15 December 2023

## **APPLICATION UNDER SECTION 72 OF THE ENVIRONMENT AND PLANNING ACT 1987 - PERMIT PA1900745-1 – MOKOAN 2 SOLAR FARM**

Figure 1 PCUs overall dimensions.

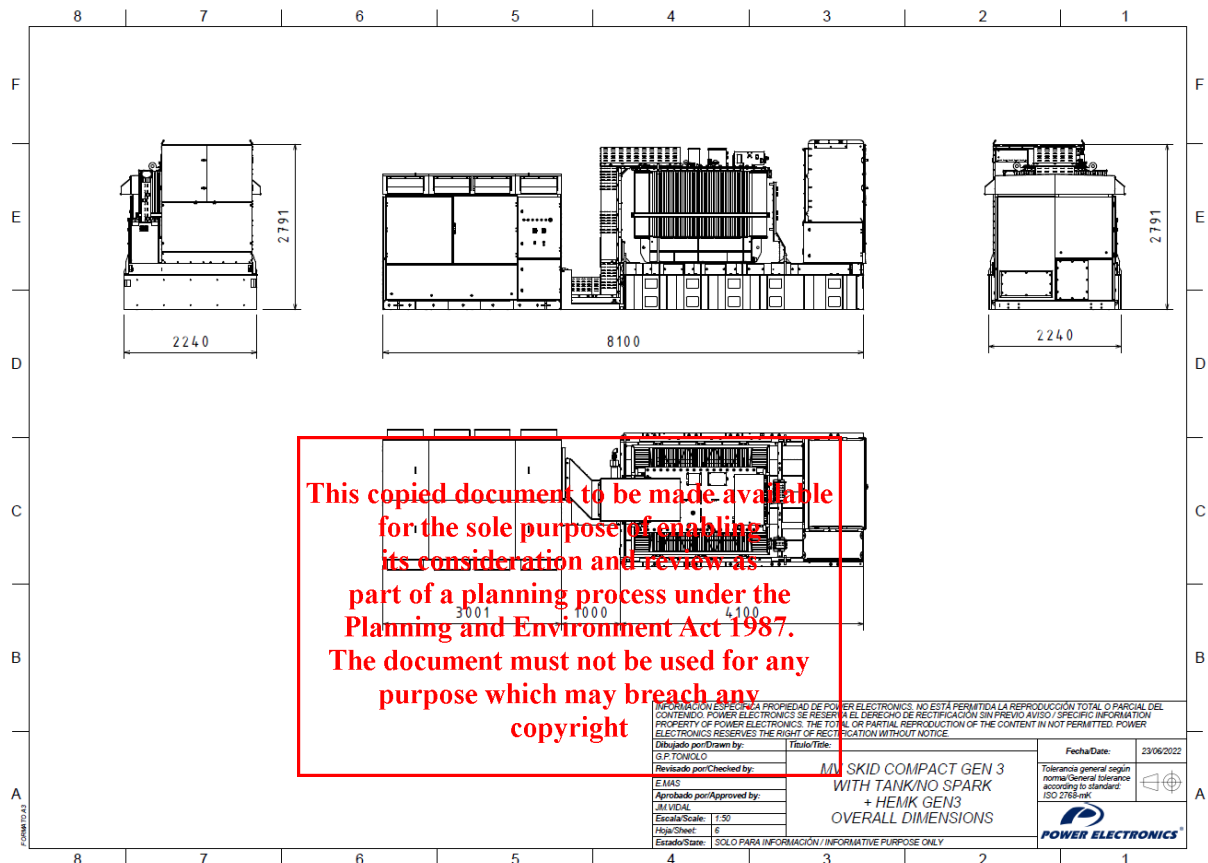
- Minor changes to the access track layout amended and passing bays included as per CFA requirements to accommodate for the new fenced area and perimeter. This avoids potential impacts on retained tree number 19.
- Relocated inverters to accommodate the new model specifications. The new model is smaller in size, leaving slightly more area to fit a number of panels (Figure 1).

Figure 3 – Updated Site plan subject of this amendment.

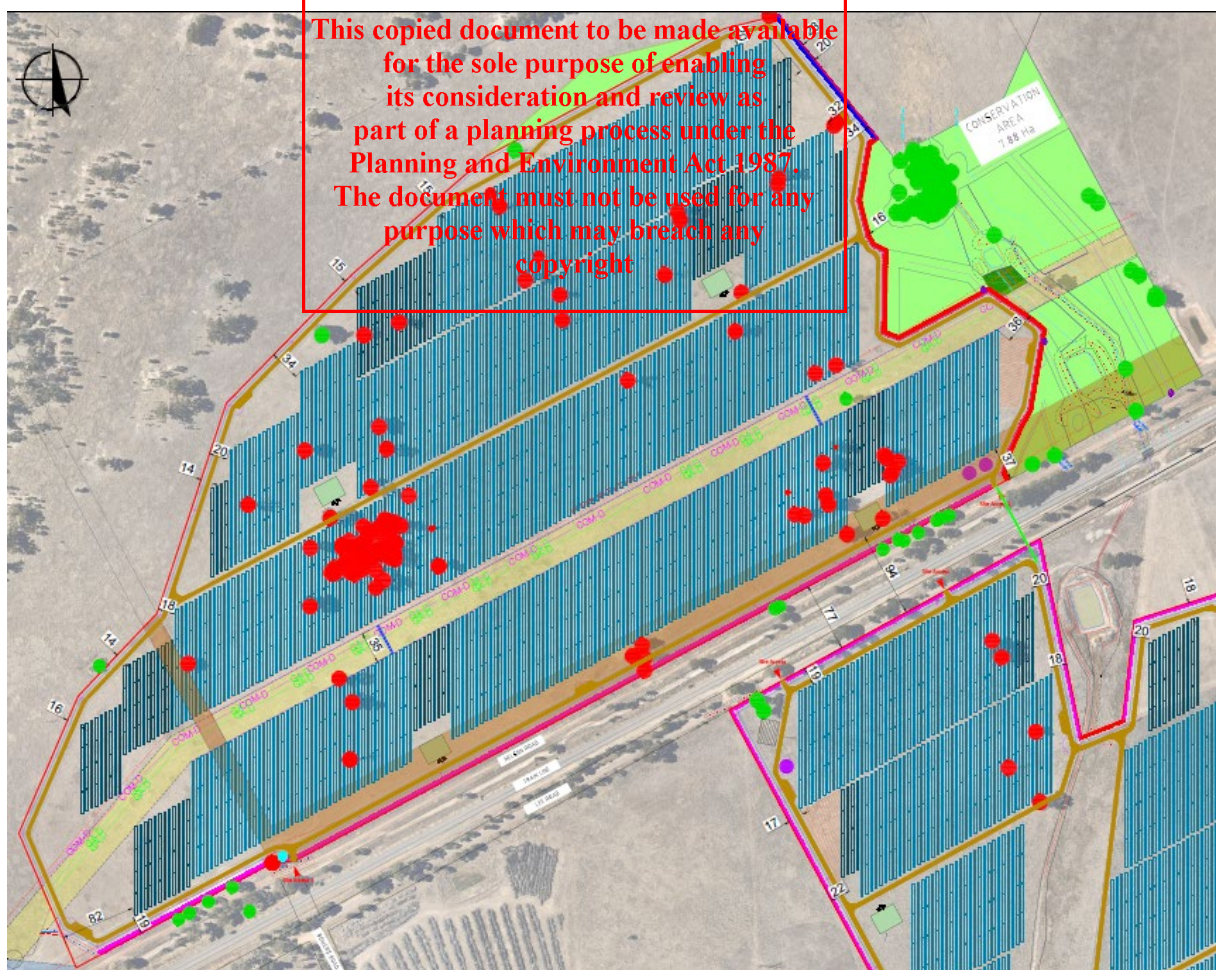
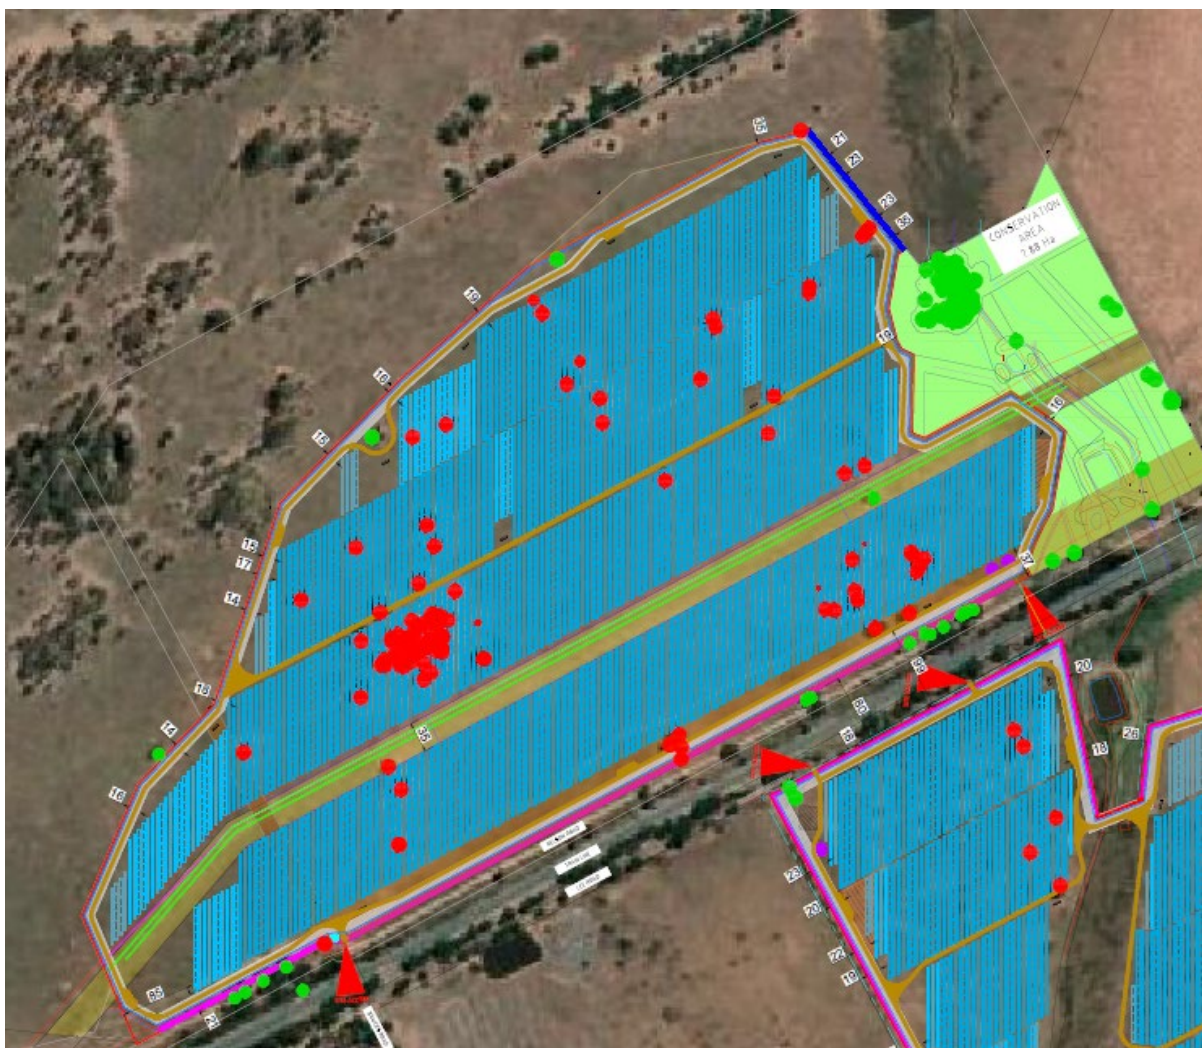
The approved site plan is 'AUS\_Mokoan\_LP2-Preliminary Design Layout\_16'. It is proposed that this be replaced with 'AUS\_Mokoan-Solar-Farm\_LP2-Preliminary Design Layout-22' (noting that the site plan also shows Mokoan 1, which was approved separately by Benalla Rural City Council permit P0070/18).

- Panel row arrangement –
  - Updated to accommodate a slight increase in the number of panels and a more efficient arrangement of infrastructure.
- The number of inverters and arrangement has changed based on the size of new models of inverters available in the market (labelled as PCUs). PCUs are made up of the inverter and transformer (refer to elevations provided). Batteries will not be installed on the project as part of the construction phase, though space has been allowed to install these on the project at a later stage during project operations. (Note: the new models have been adopted because the old models have been discontinued)

- Note outlining the resting angle of the trackers is shown. Resting angle between 5 and 7 pm is provided to avoid glare and glint impacts.
- Landscaping Plan changes:
